PLAN COMMISSION STAFF REPORT

Agenda Item: PC 25-012

Application Type: Development Plan

Summary: Applicant is requesting review and consideration for a single-site Development Plan to include employee off-street parking, vehicular emergency exit connection, screening, landscaping, lighting, and refuse area at Crew Car Wash located at 111 Ridge Road.

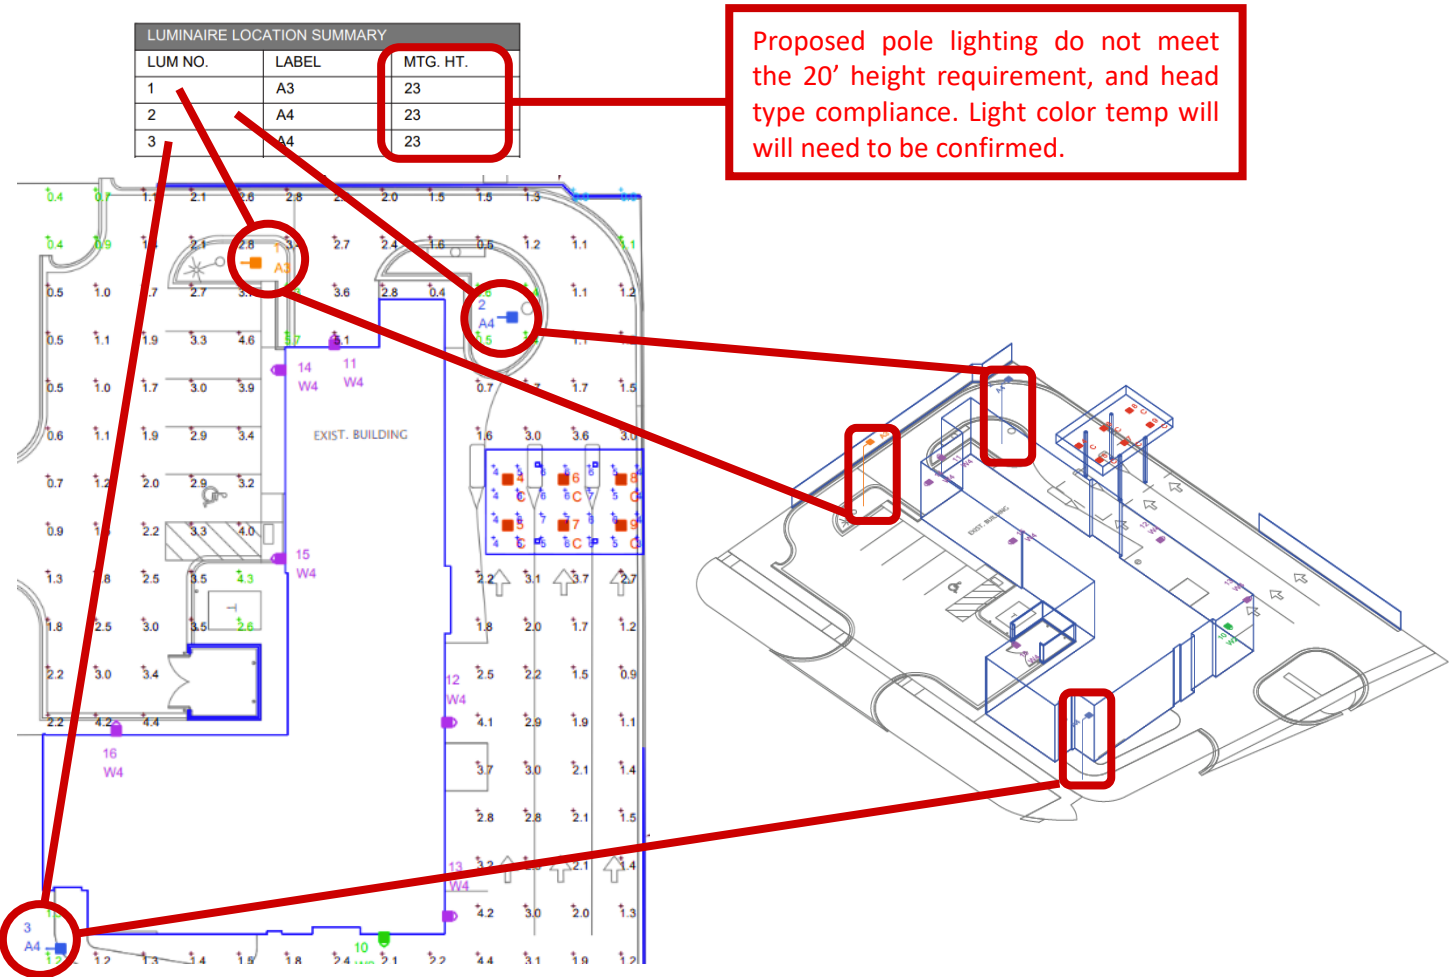
Additional information requested for the proposed pole lights was submitted and it does not comply with the town lighting standards. Manufacturer specs for the pole lights will need to comply with the Character Based Zoning Code or secure a BZA Variance approval.

Proposed Lighting Review:

Motion to APPROVE PC 25-012 Crew Car Wash Development Plan with the condition that all lighting specs comply with the Town's standards and that a guard/gate arm be installed at the proposed emergency exit drive aisle, including all discussion and findings.

OSQ Series

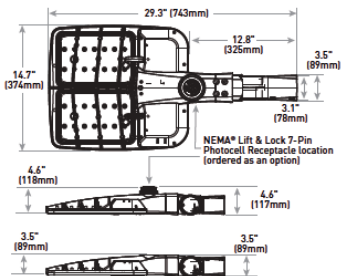
Staff finds the applicant and interested parties have submitted a complete application, including limited power of attorney affidavit, as well as fulfilling the Public Notice Requirements. However, staff finds the proposed pole lights do not comply with the Town's lighting standards. Also, staff have not identified a guard arm/gate for the proposed emergency exit as previously recommended by the plan commission.
